Based on GRVA-05-07-Rev.3:

- without Annex 4 (subject of IWG VMAD)
- without para. 8 for DSSAD (subject of IWG EDR/DSSAD) – also DSSAD related para. (e.g. definitions) were not reviewed by IWG ACSF
- no review regarding Cybersecurity and Software-updates undertaken by IWG ACSF
- All other changes in in **bold** or ~~strikethrough~~

Proposal for a new UN Regulation on

Uniform provisions concerning the approval of vehicles with regard to Automated Lane Keeping Systems

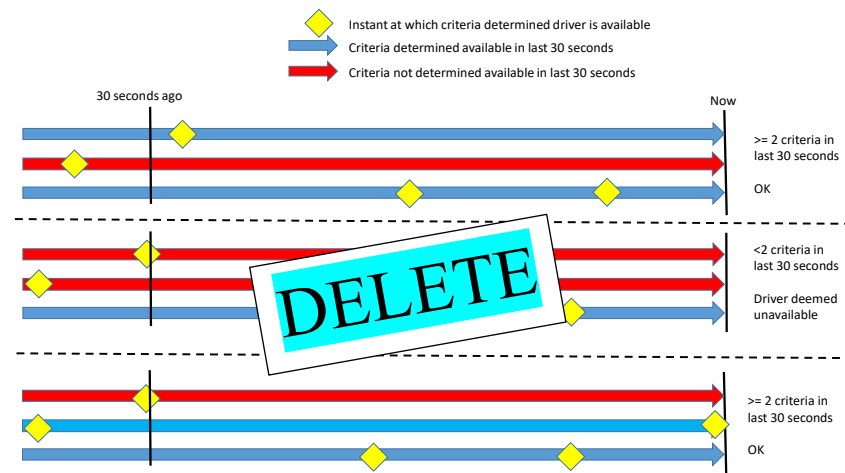
Remark ACSF: Diagram above introduced to delete the diagram below!
